DATE: July 25, 2016

RE: Addendum No. 2 to the Bidding Documents for:
YORK HOUSING AUTHORITY
OFFICE ADDITION
YORK, NEBRASKA
Schemmer Project No. 06794.001

SHEET TITLE: ADDENDUM NO.2 - SECTION @ ROOF EXPANSION JOINT

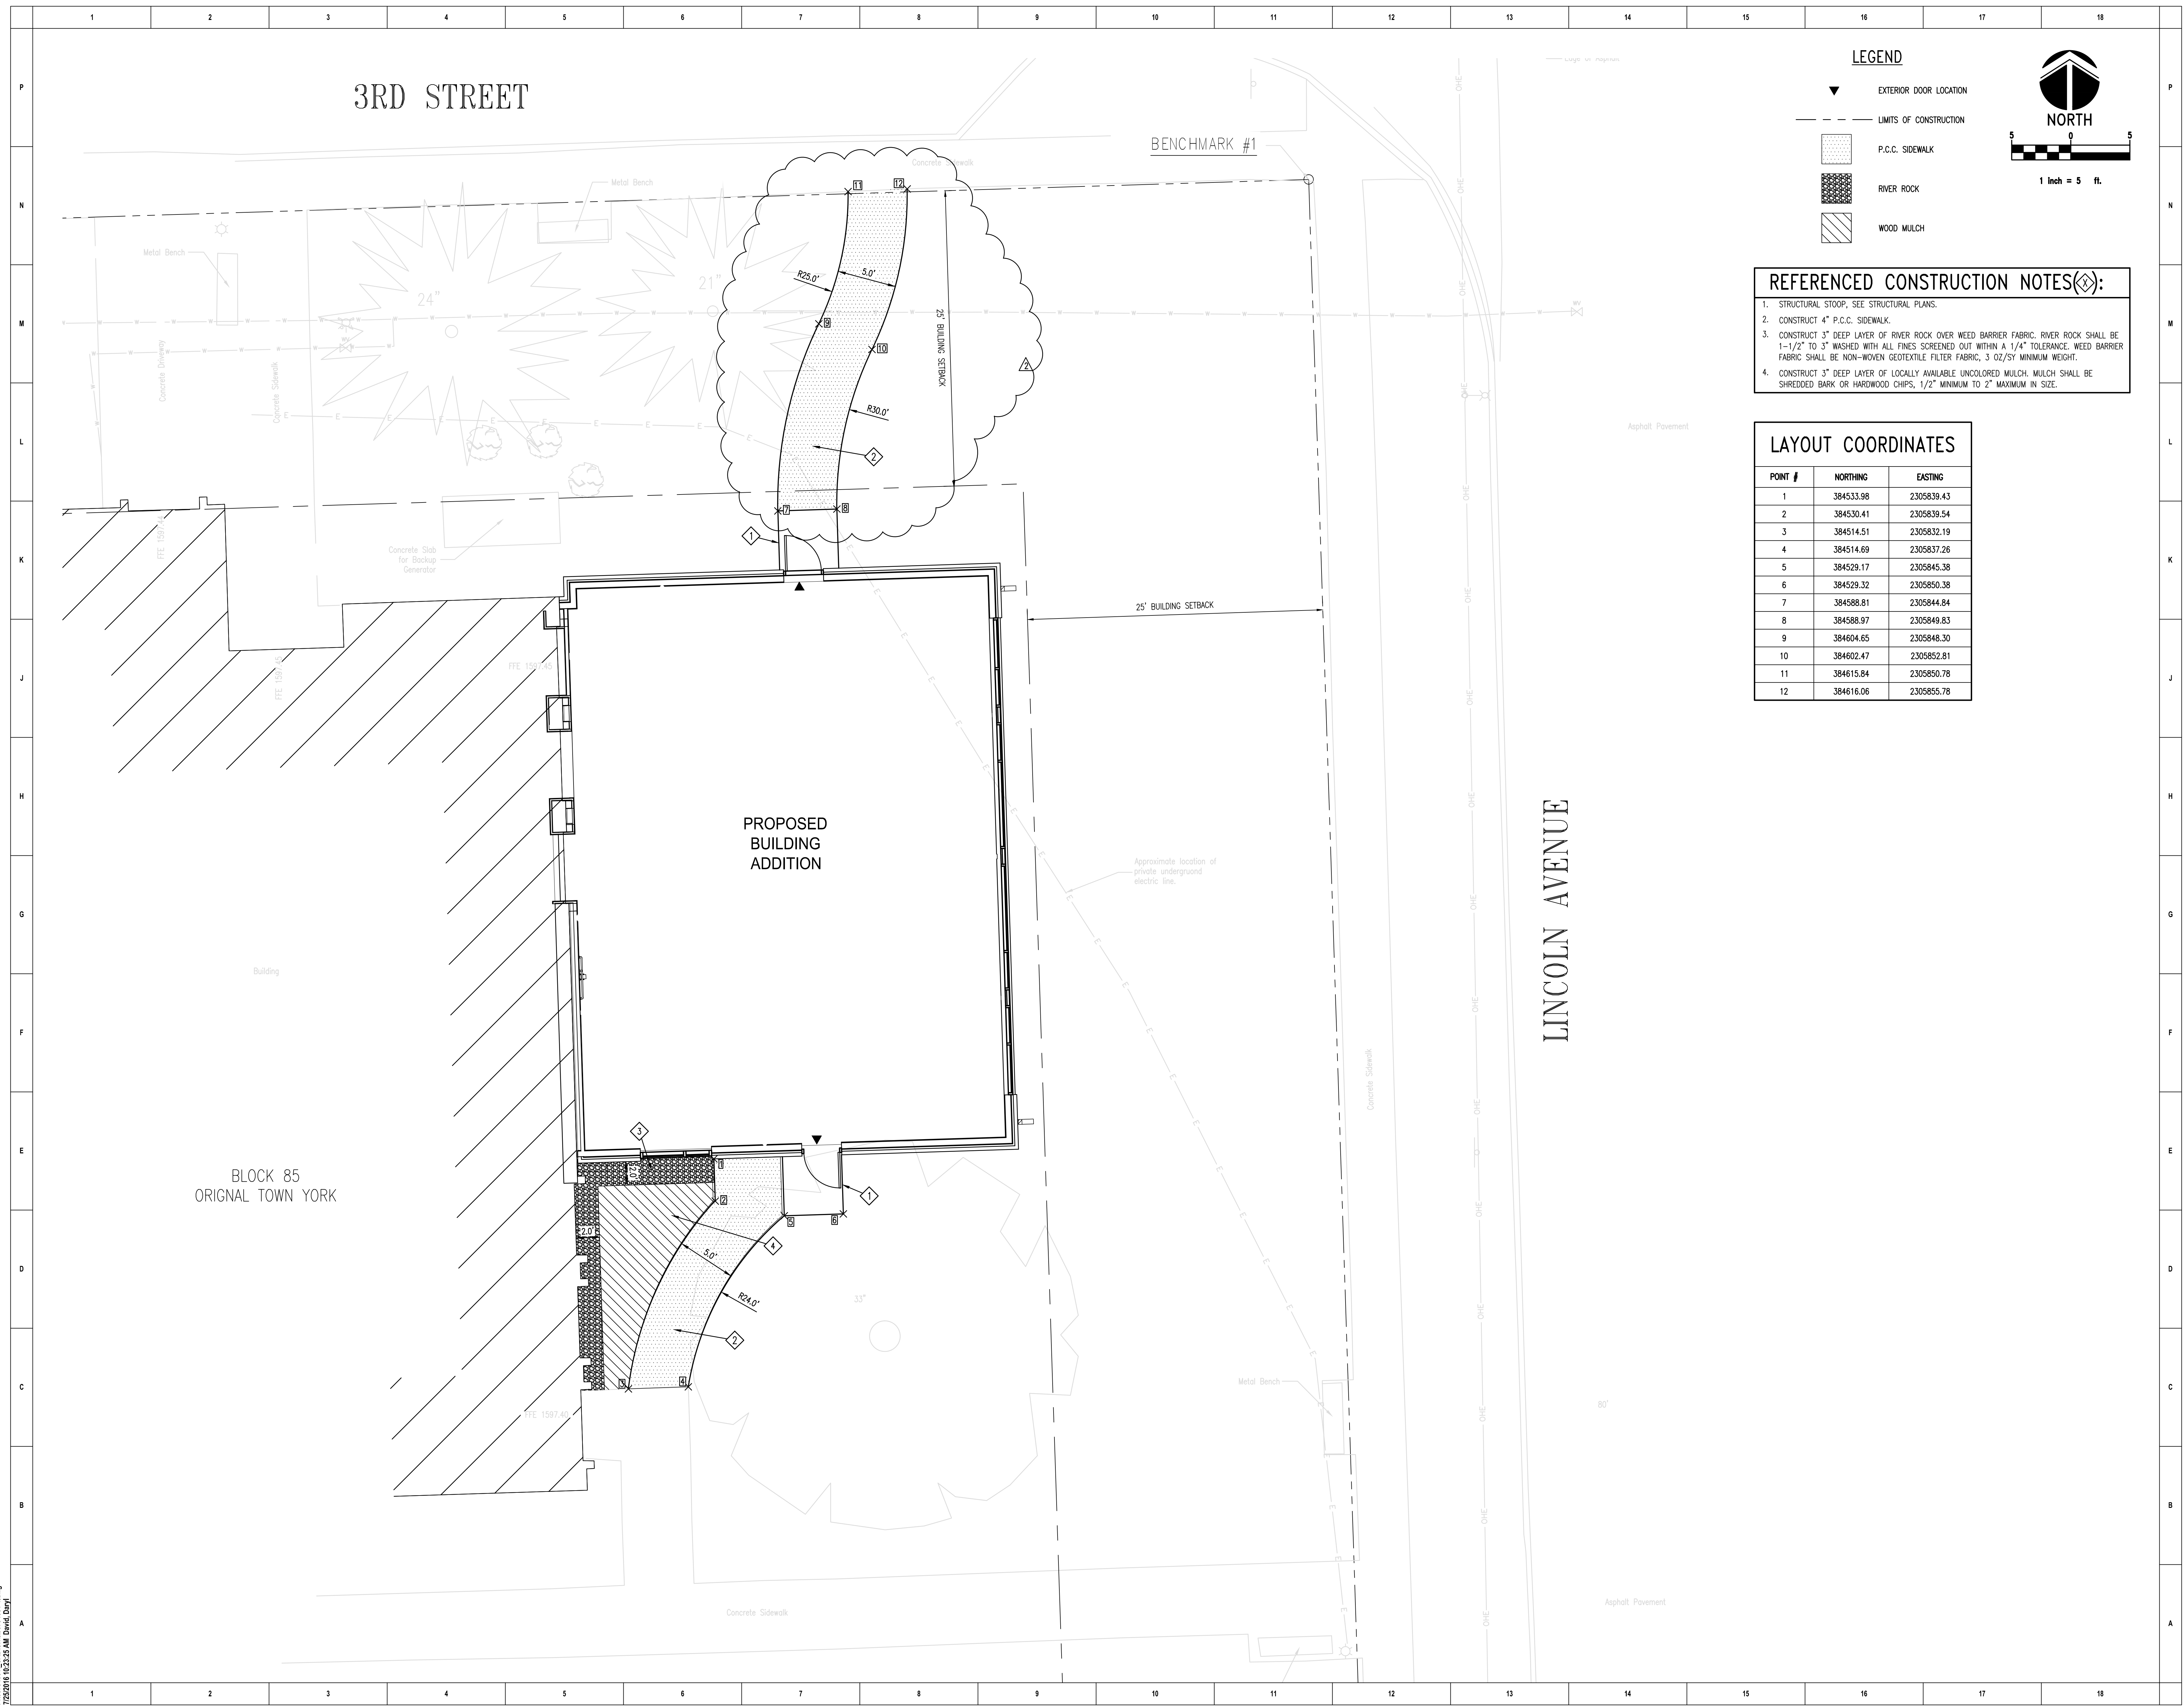
Item No. DA-2, Sheet A2-03

Referencing attached Revision 1 - Detail 4/A2-03,

Add reinforced membrane strips as indicated at each side of roof expansion joint.
